EPC STORMWATER REVIEW COMMENTS  
IN ORANGE BOXES WITH BLACK TEXT

**Preliminary Drainage Report**  
**Meadow Lake Industrial Filing No. 1**  
**El Paso County, Colorado**

August, 2023

PCD File No. TBD **SP236**

## Basin OS1 Culvert

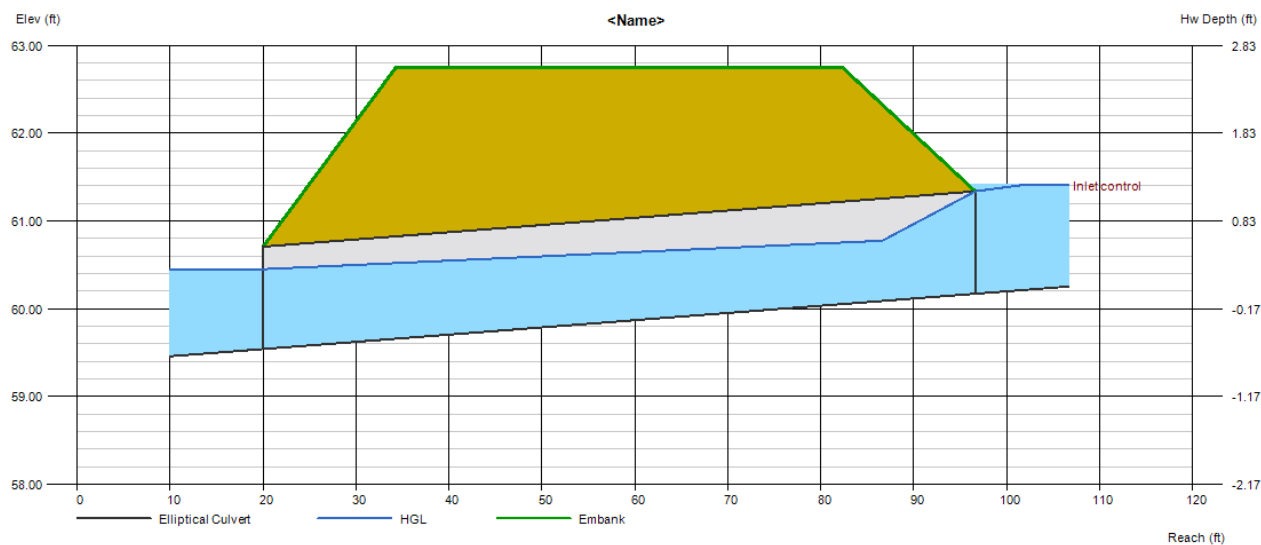
Culvert is not shown with headwall. Revise or change design.

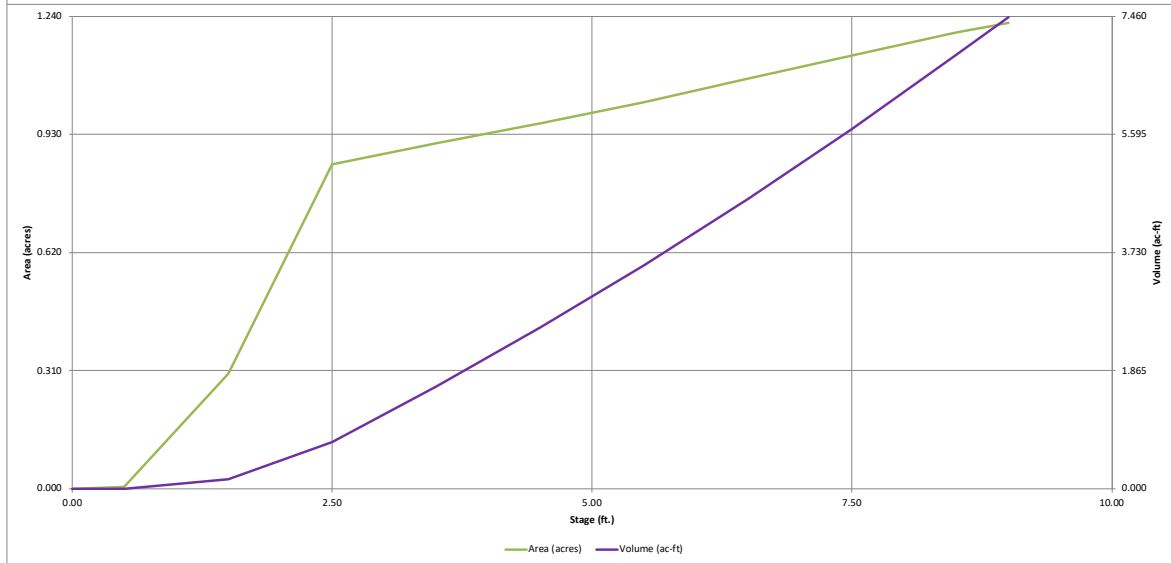
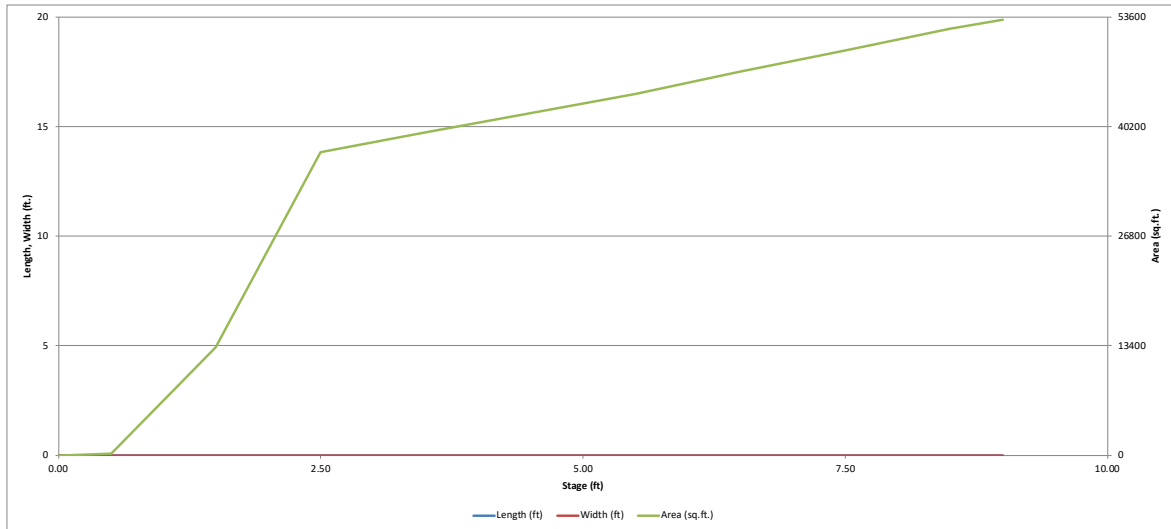
Label Pond A to match plans

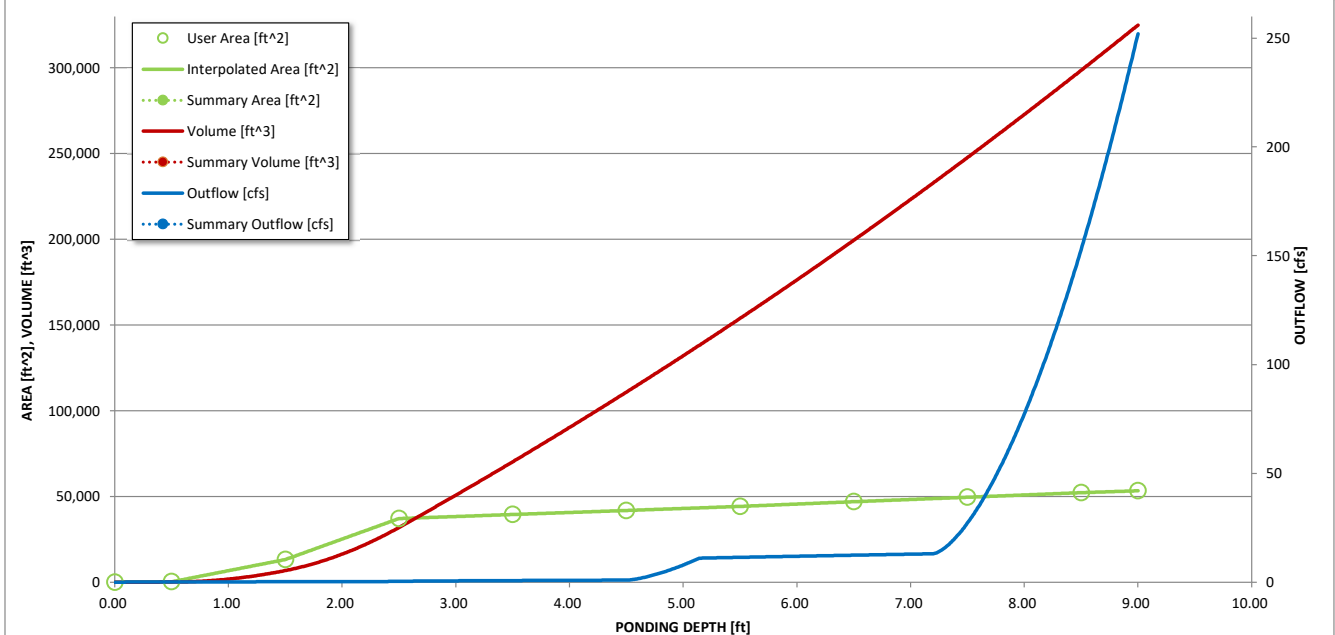
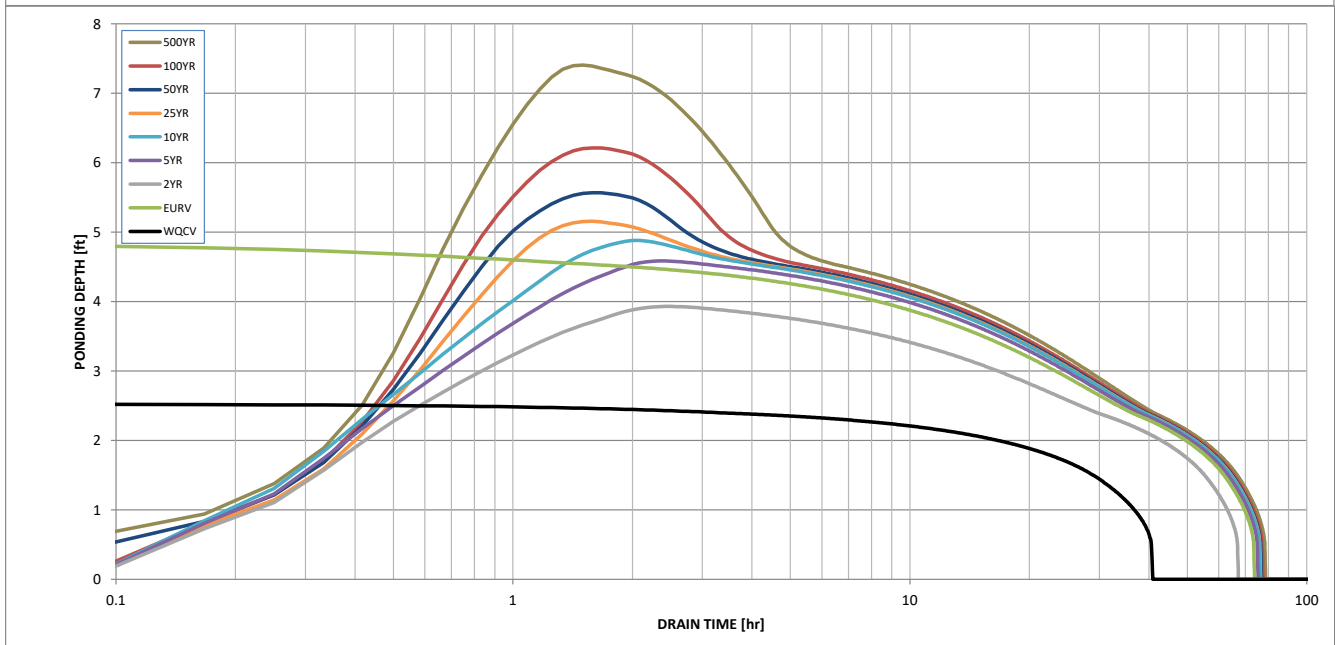
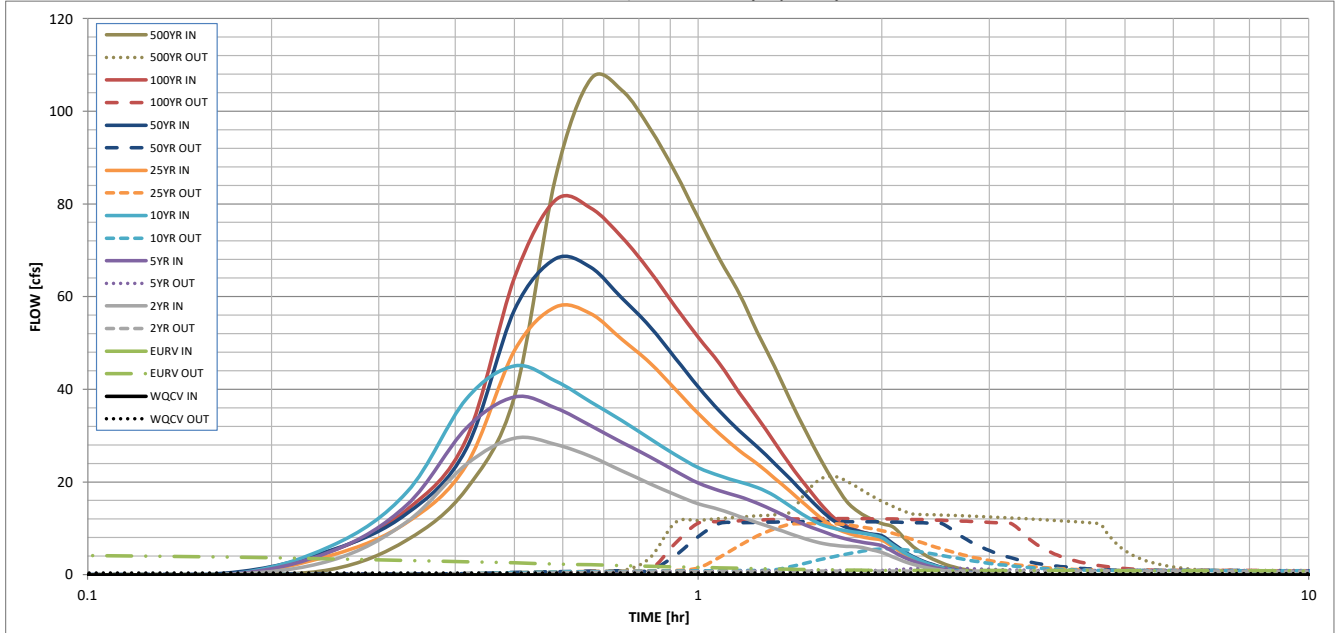
Why are all these values N/A?

Provide hydrology calcs to support the override predevelopment Q - the existing condition Q's are not comparable because the basins analyzed are drastically different from the proposed condition.

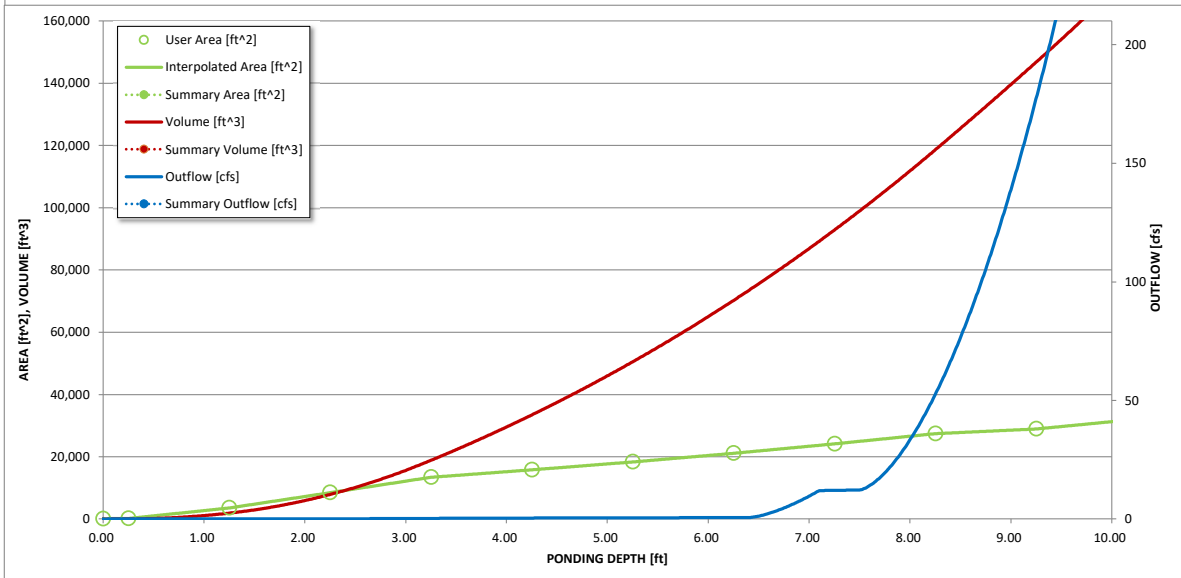
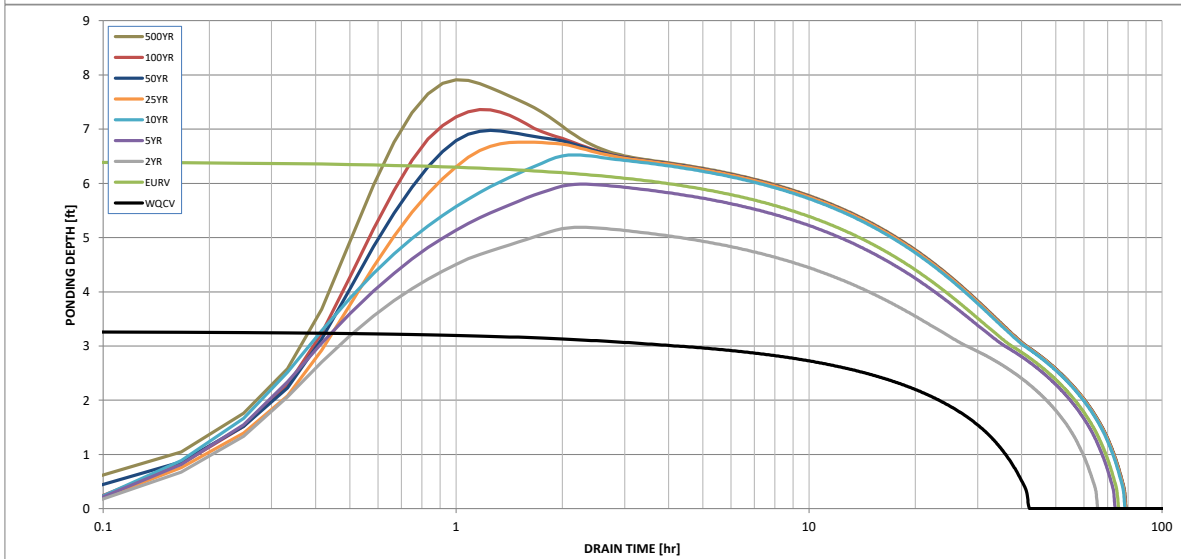
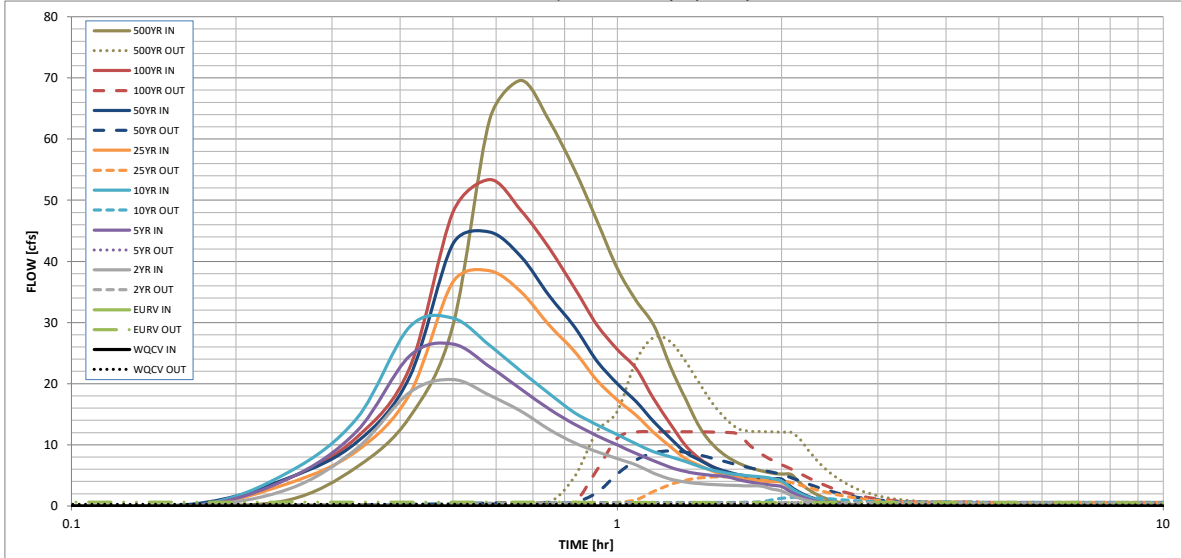
Why are all these values N/A?

Provide hydrology calcs to support the override predevelopment Q - the existing condition Q's are not comparable because the basins analyzed are drastically different from the proposed condition.

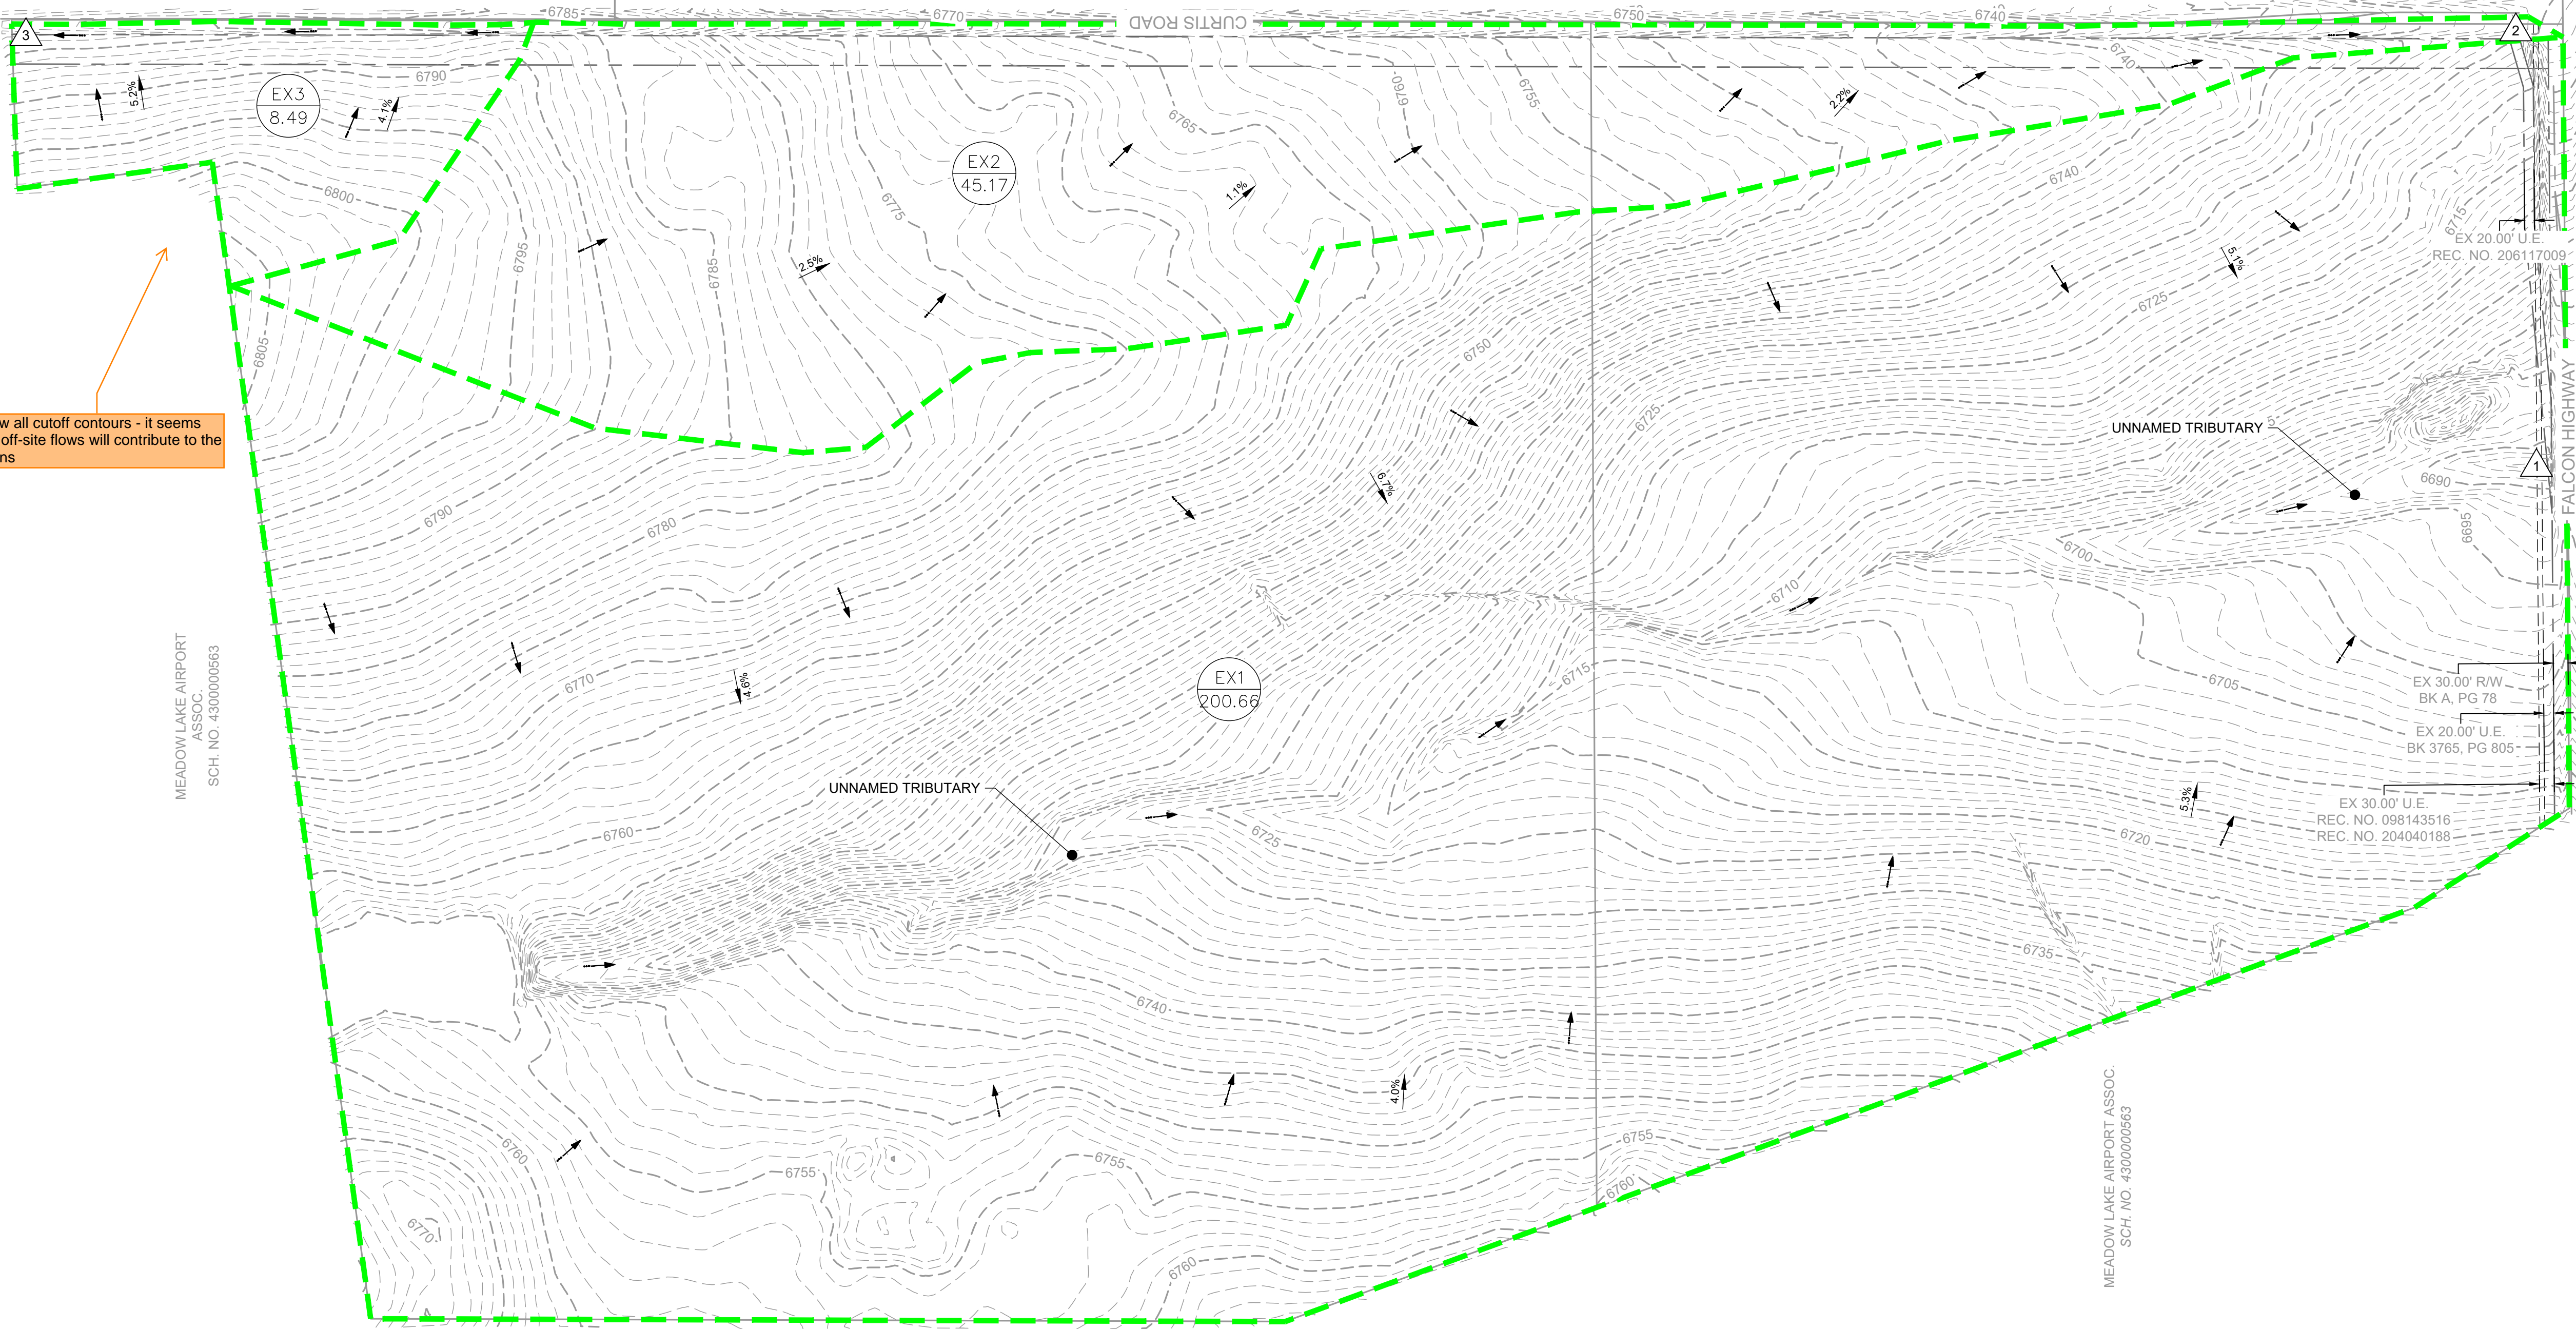
Revise to show offsite basins and revise summary table to show how much offsite runoff travels through site.

Update map to show FEMA floodplain boundaries.

Show all cutoff contours - it seems that off-site flows will contribute to the basins

comments have been provided on the Preliminary Plan to provide turnarounds at the north and southern end of Greenfield Ave. Please account for this in your design.

please indicate the required easement width to contain the flow within swale and coordinate with project planner so that it is indicated in the preliminary plan

Show proposed contour tie ins to existing.

Show proposed contour tie ins to existing.

Revise to show a blowup of this section where the swale meets pond. Need additional clarity as to how swale will enter pond.

please indicate the required easement width to contain the flow within swale and coordinate with project planner so that it is indicated in the preliminary plan
